SEWAGE DISPOSAL TESTING

STATE OF MARYLAND - DEPARTMENT OF HEALTH AND MENTAL HYGIENE

SUBDIVISION Triadelphia Farms IILOT NO. 9D

TITLE PERCOLATION TEST PLAT			
PROJECT TRIADELPHIA FARMS II · LOT 9D			
LOCATION 3RD ELECTION DISTRICT		HOWARD COUNTY, MARYLAND	
DATE: MARCH, 1979	DESIGN BY: —	DRAWN BY: D.L.C.	CHECKED BY: J.A.B.
SCALE: 1" = 100'	JOB NO.: 77228	DRAWING NO.: 1 OF 1	
boender associates		engineers surveyors planners	
BALTIMORE 301-465-7777 ♦ SALISBURY 301-749-1286

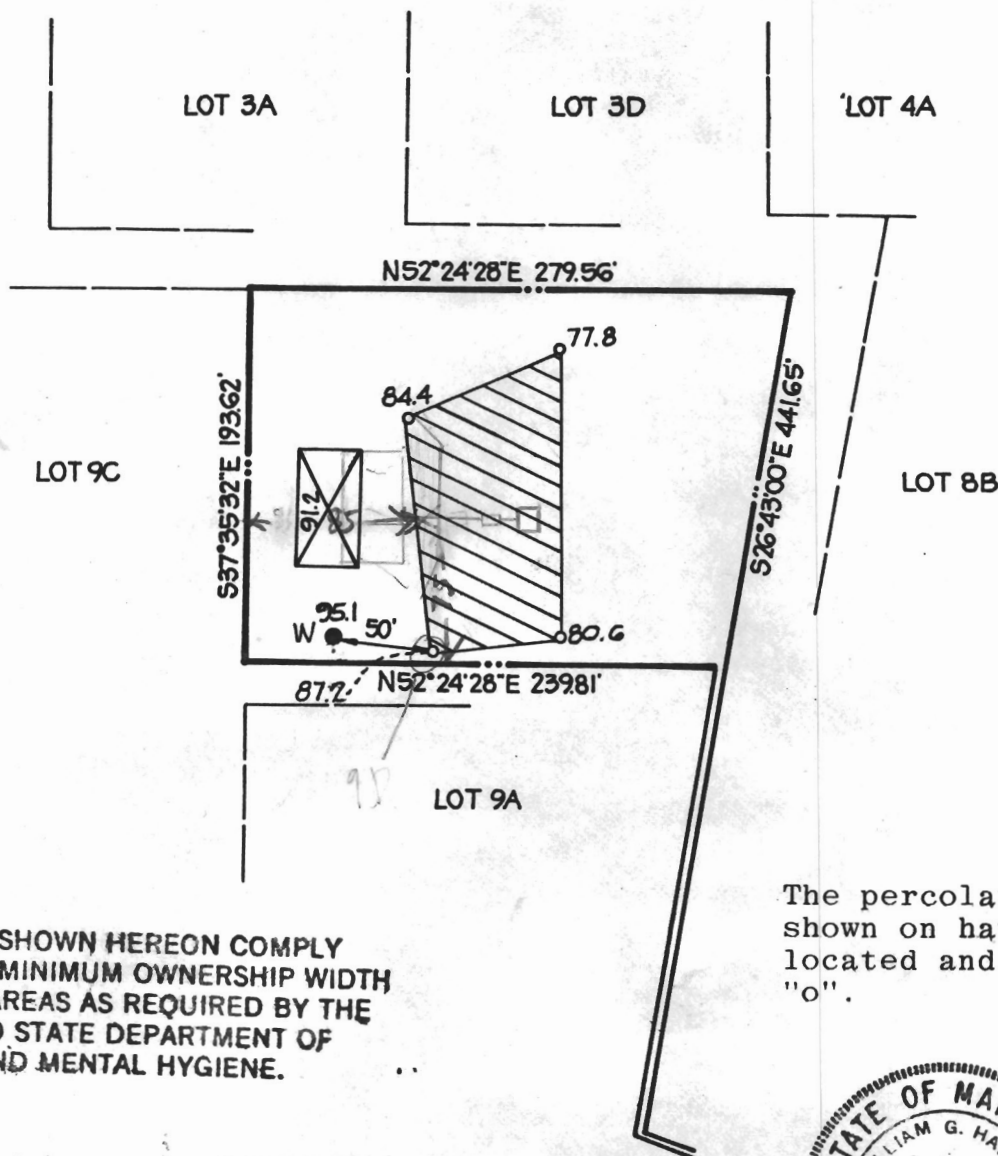
Underground water at 5' & 12' in lower holes3/12/79 - HOLD FOR REVIEW WATER IN 1978J. S. BUT NOT 1979 RH4/26/79 HOLD FOR REVIEW PERC OK BUT PLAT MUST SHOW
GOOD WELL SITE & SEWAGE AREA IN RELATION TO ADJACENT
LOT RATION 11/27/78 BUENDER SAID THIS PLAT SIGNED**THIS IS NOT A PERMIT**

BY HQ WHEN I WAS ON VACATION RH
